Aberdeen Cycle Forum response to proposed design of Western Peripheral Route.

Figure 1

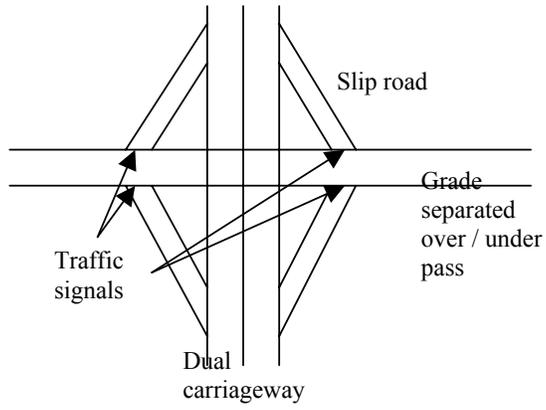
There appeared to be no proposed signal controlled junctions. On the whole signal controlled junctions are the most favourable to cycle traffic, whether (a) signal controlled roundabouts, or preferably (b) signal-controlled T-junction / crossroads (see Fig 1).

- (b) An example of a grade-separated signal controlled crossroad style junction is the Hammersmith junction (A4) in West London. (This is not an ideal example – there are other junctions that resemble Fig 1 more closely, but the ACF has not been able to identify a suitable example in time for inclusion in this report.)
